YANKEE NUCLEAR POWER STATION (YANKEE-ROWE)

Amendment No. 3C  
License No. DPR-3

ATTACHMENT TO LICENSE AMENDMENT NO. 30

Revise the Technical Specifications as follows:

PERMISSIVE RELAY CIRCUIT

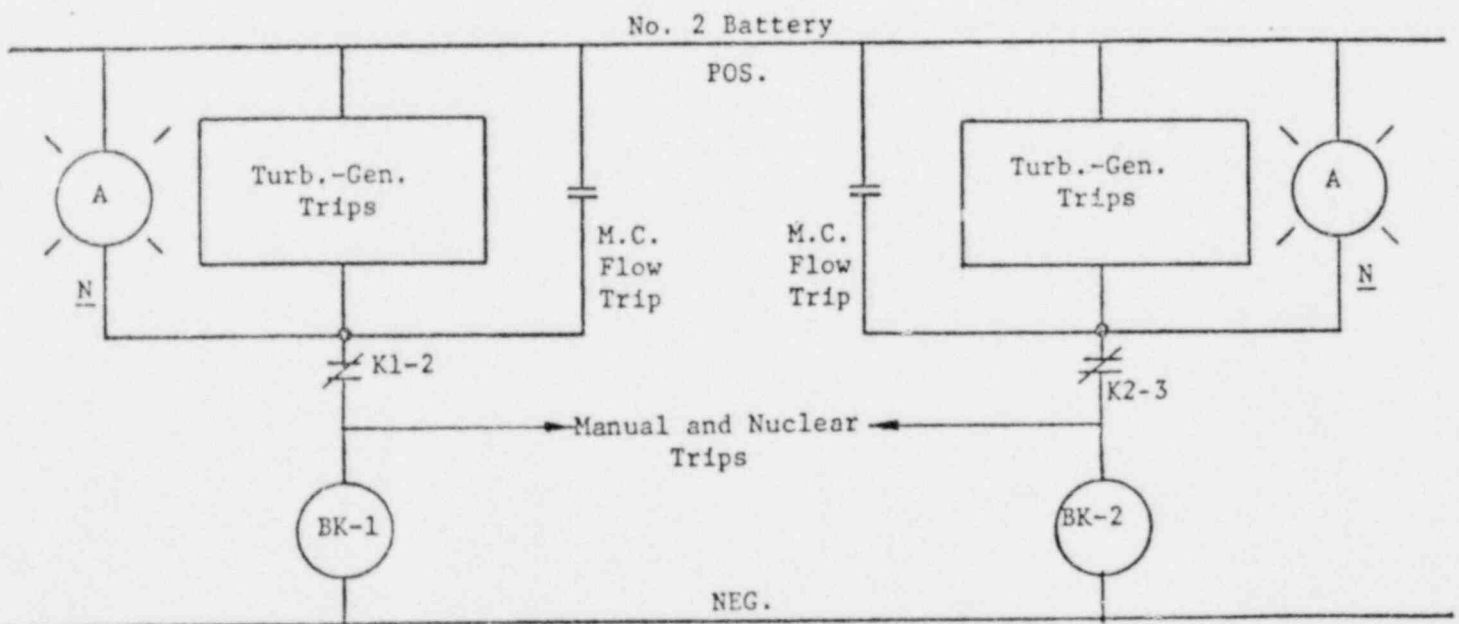
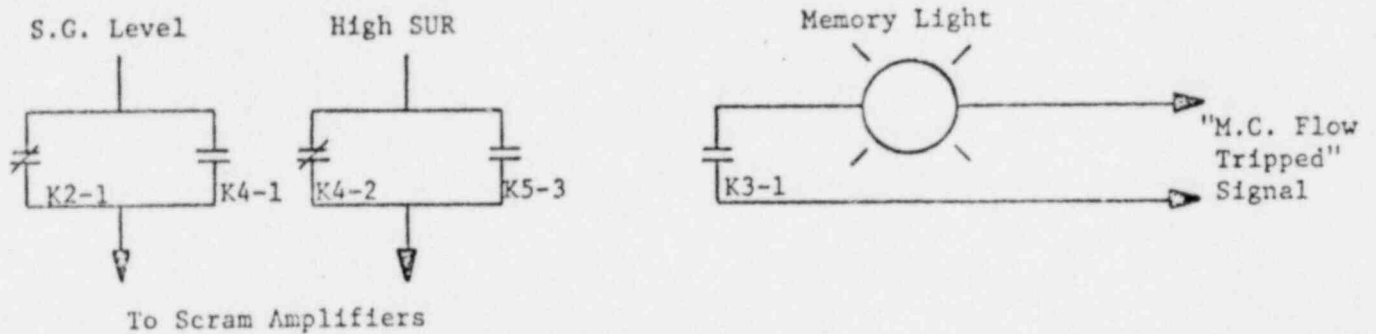
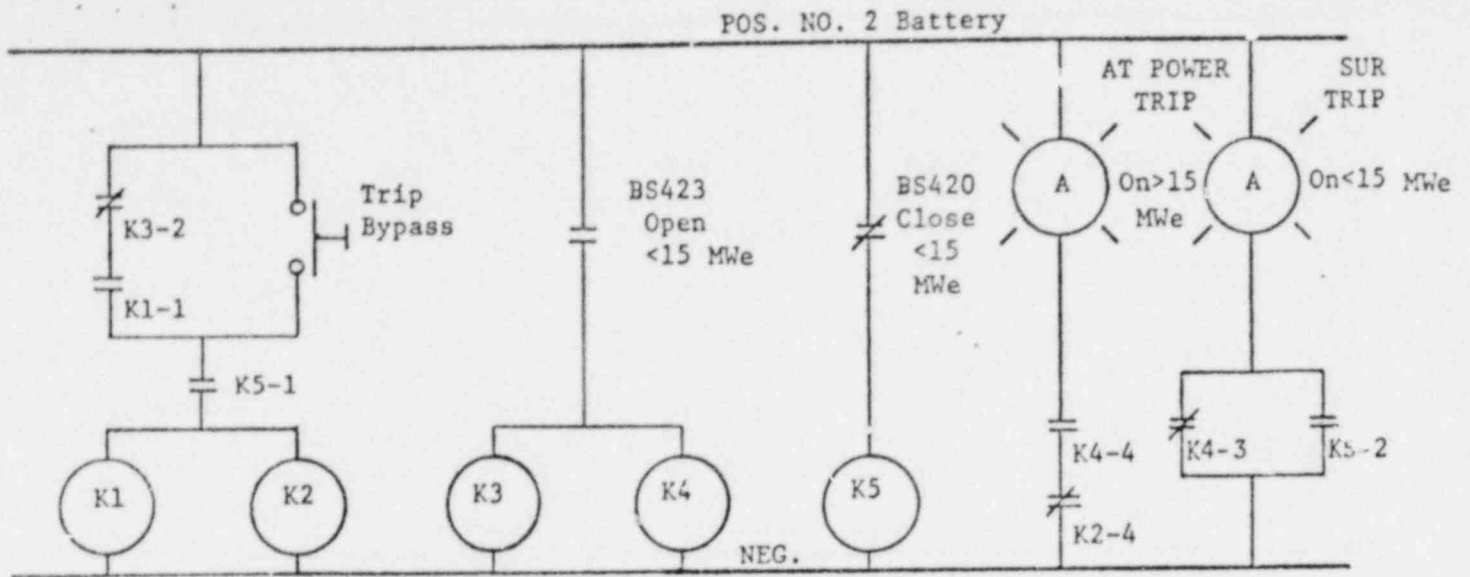
Remove pages 214:5, 214:6 from the Final Hazards Summary Report and replace with revised identically numbered pages.

A permissive relay circuit, shown on page 214:6, is provided which is operated by two millivolt bistables activated from two MWe thermal converters. Operation of the circuit occurs at a generator output of 15 MWe. This circuitry provides for an optional manual by-pass for the low steam generator level scram, low flow scram and turbine-generator scram signals when the power is below 15 MWe. At 15 MWe and above, the scram bypass is automatically removed. The high startup rate scram signal is automatically connected at 15 MWe and below, and automatically bypassed above 15 MWe.

A second permissive relay circuit is actuated, by a third millivolt bistable and thermal converter, at the 130 MWe power level, which provides for automatic cut-in of a manual rods out reset circuit. At power levels of 130 MWe and above, the reset circuit requires the control switch to be returned to the neutral or reset position before making each additional rods out step. Below 130 MWe output, the reset circuit becomes
